Subject: AP1000 Response to Request for Additional Information (SRP)

RAI-SRP14.3.2-CCIB-04

RAI Response Number: RAI-SRP14.3.2-CCIB-04

The image below is from APP-GW-GLN-147 and shows the plate configuration.

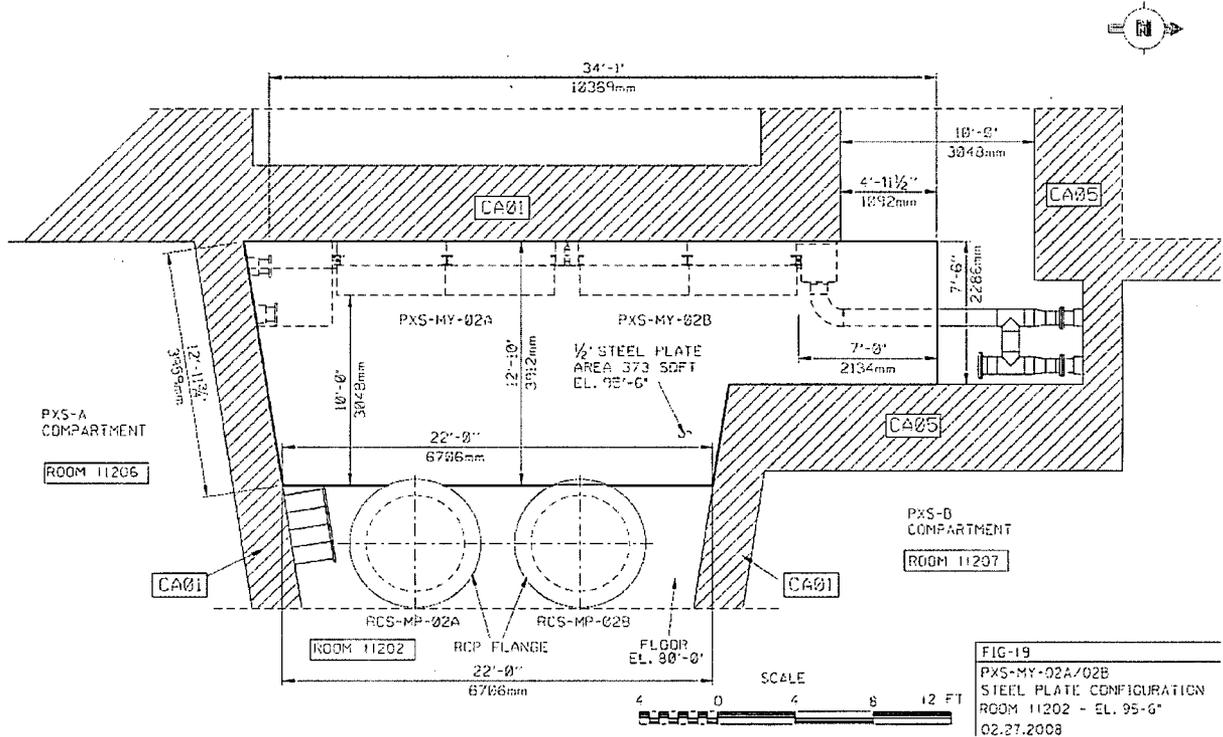
In ITAAC Table 2.2.3-4, for design commitment Item 8.c, ITA item vii states: "Inspections of the as-built components will be conducted for plates located above the containment recirculation screens." The AC item vii states that: "plates located above each containment recirculation screen are no more than 1 foot above the top of the screen and extend out at least 10 feet perpendicular to and at least 7 feet to the side of the screen surface."

The staff asks the applicant to explain the following: a) if there is to be one solid plate or if many individual plates are permitted above each recirculation screen, b) is there a minimum height of the plates above the top of the screens or can the plates be in contact with the screens, c) what is the required thickness of the plate or plates provided, d) the orientation of the plates to the screens since it is not clear as to what is perpendicular to the screens and what are the sides of the screens, and d) is the dimension of at least 7 feet to the side of the screen surface for only one side or two. The staff requests that the details provided in the applicant's explanation be incorporated into AC item vii.

- a) The configuration is to use many plates is to form a continuous / solid plate arrangement to cover each containment recirculation screen that provides a relatively lengthy path for fluid entry into the screen surface (inlet). A continuous plate configuration prevents having any paths that would allow debris to bypass the entire plate lengths specified and enter the recirculation screens, rather than either settling out on top of the plate or having the plate direct the flow past the ends of the plate (relatively far away from the screen surface inlet), to provide the anticipated settling distance prior to the flow reaching the screen surface.

- b) There is no minimum height of the plates above the top of the recirculation screens, so a minimum distance does not need to be specified in the ITAAC AC. The intent is that the plate be vertically close enough to the screen surface to effectively re-direct flow around the plate before entering the screen, to optimize debris settling. This precludes debris that may

be settling from anywhere above the screens from entering the screen surface. Placing the plates at any position within one foot above the top of the screens is acceptable for purposes of minimizing debris entry into the screen surface.

- c) The plate thickness is not required to specified in the ITAAC AC since the design information related to plate thickness is appropriately addressed in other portions of the ITAAC. The plate design dimensions (such as plate thickness) related to material strength that do not materially affect the debris flow are addressed in Item 5.a of Table 2.2.3-4.
- d) As discussed in Items a) and b) above, the intent of the screen plates is to re-direct flow to increase the flow path length to the screen surface, or its inlet where the water flow enters the screen pockets, through the "pocket frontal face area" discussed in Item viii).

In the prescribed ITAAC AC arrangement, the plate must extend out at least 10 feet perpendicular to the screen face. This then requires that the flow must move back underneath the plate for this 10-foot flow path before entering the screen surface. This specified distance provides a sufficient settling distance for the containment recirculation flow entering the screen surface.

The plates above each recirculation screen are also required to extend out at least 7 feet to the side of the screen surface to accomplish the same flow path objective to increase the screen surface entry flow path as discussed in Item d), which maximizes debris settling before entry into the screen surface. The requirement for the plates to extend out to the sides applies to both sides of each screen, where practical. For example, the screen which is aligned nearest the south wall of the steam generator compartment (MY-Y02A) has a concrete wall within 7 feet of the side of the screen and, therefore, there is no need to have 7 feet of steel plate to that side of this screen. In this instance, the steel plate extends only to the concrete wall. The AC specifies that "(vii) Plates located above each containment recirculation screen...and extend out at least 10 ft perpendicular to and at least 7 ft to the side of the screen surface." This requirement applies to each side of the screen. The side of a screen is explained in the third paragraph in the discussion for Item d) above.
